REFERENCE: C.N.274.1996.TREATIES-53 (Depositary Notification)

AMENDMENTS PROPOSED TO REGULATION NO. 90

TRANS/WP.29/509

DRAFT SUPPLEMENT 2 TO THE 01 SERIES OF AMENDMENTS TO REGULATION No. 90
(Replacement brake linings)

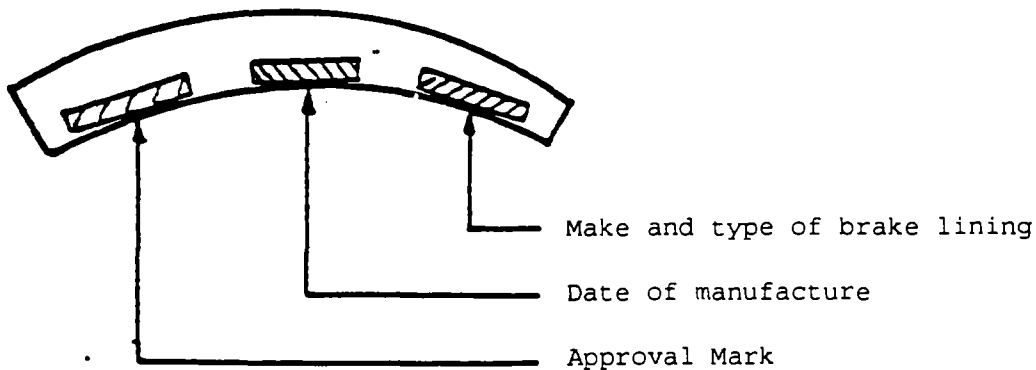
Item 3, amend to read:

"3. Make and type of brake lining assembly/drum brake lining 2/
....."
